ICHD - ENVIRONMENTAL HEALTH DIVISION

SEPTIC: IMPROVEMENT PERMIT / AUTHORIZATION TO CONSTRUCT / OPERATION PERMIT / EXISTING SYSTEM

PERMIT # OSWP-2022-8477

Artisan Custom Homes
Murphy Residence WWTS

AS BUILT SKETCH

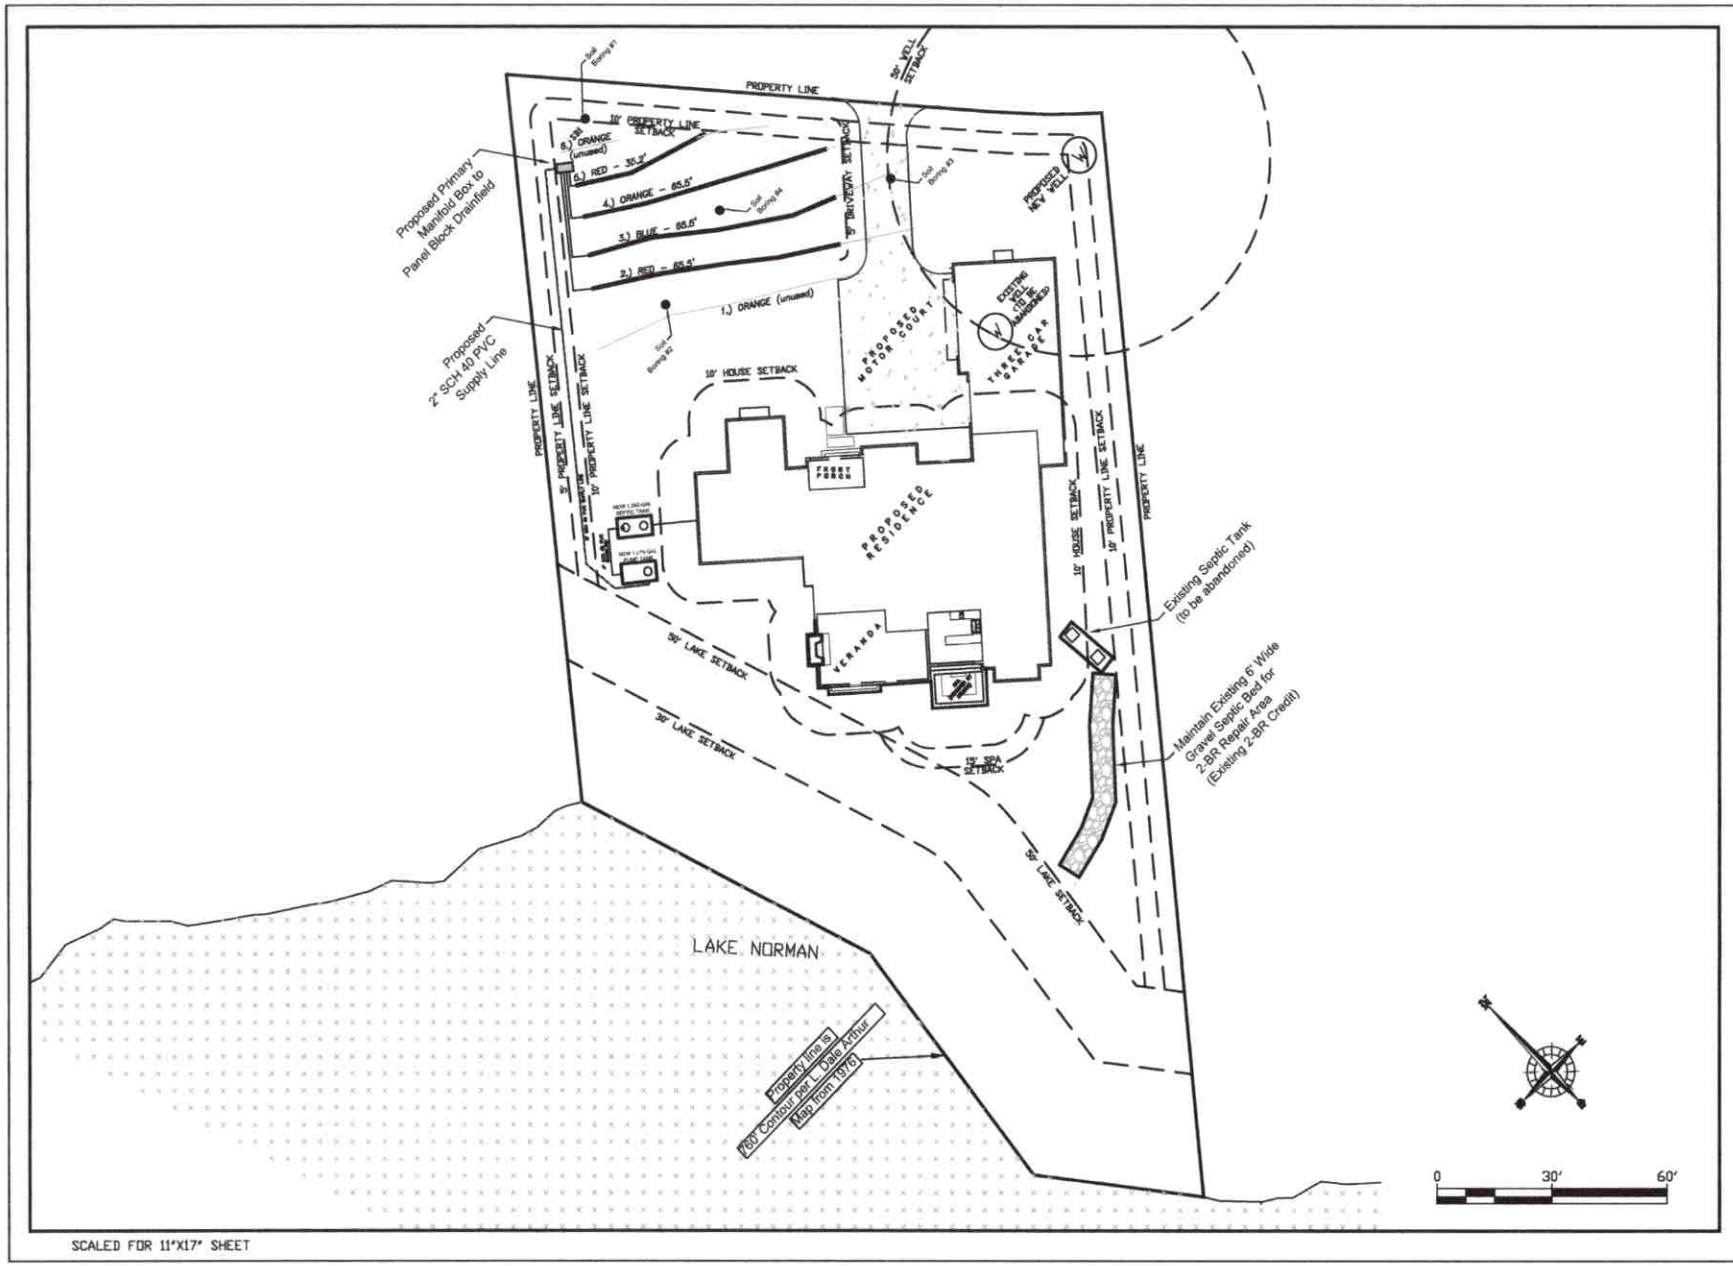
Alarm did not on Irrigation by septic line

Electrical not on separate breakers or split between Alarm & Pump. MW.

SHEET TITLE
Property Layout

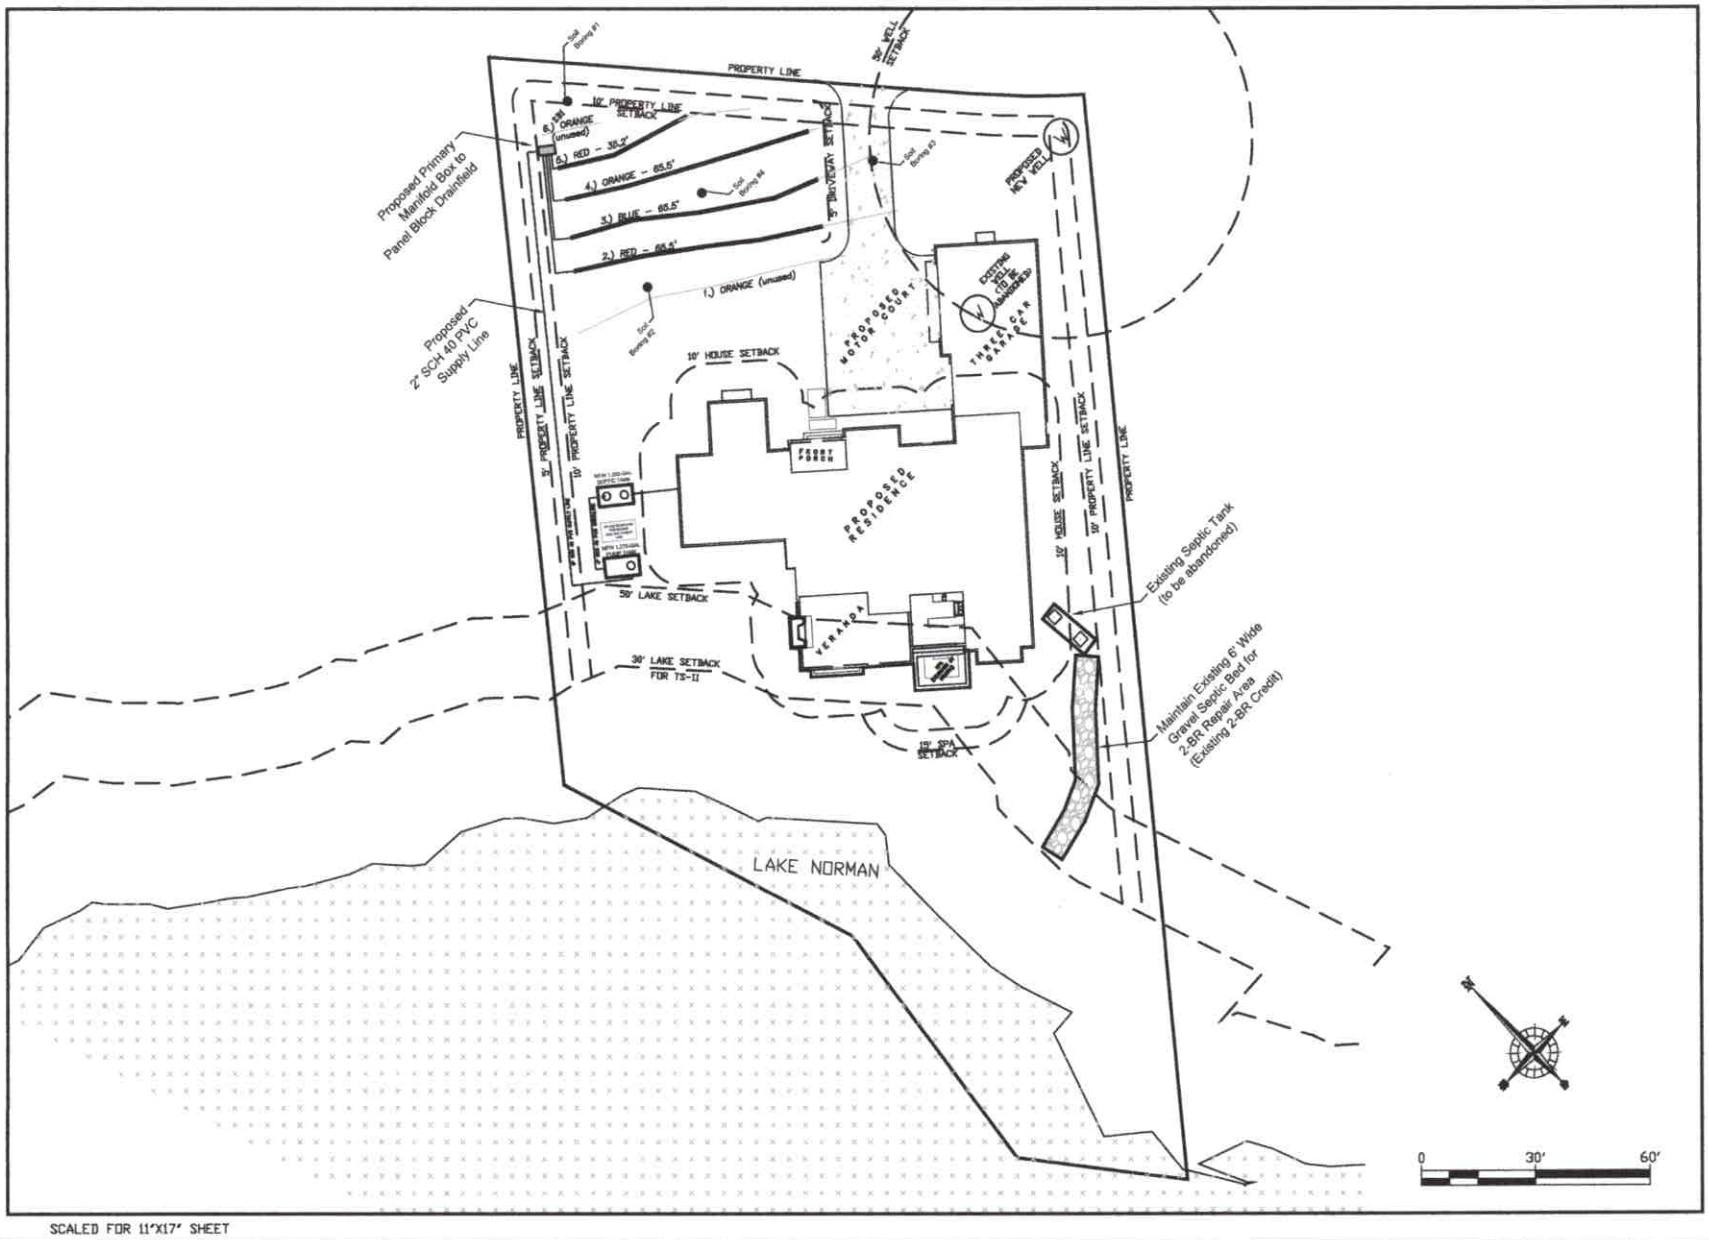
1) Current site plan shows house in the buffer - update site plan in septic permit packet.

REV.	ISSUED DATE	DESCRIPTION
1.)	11/22/22	Revised Setbacks
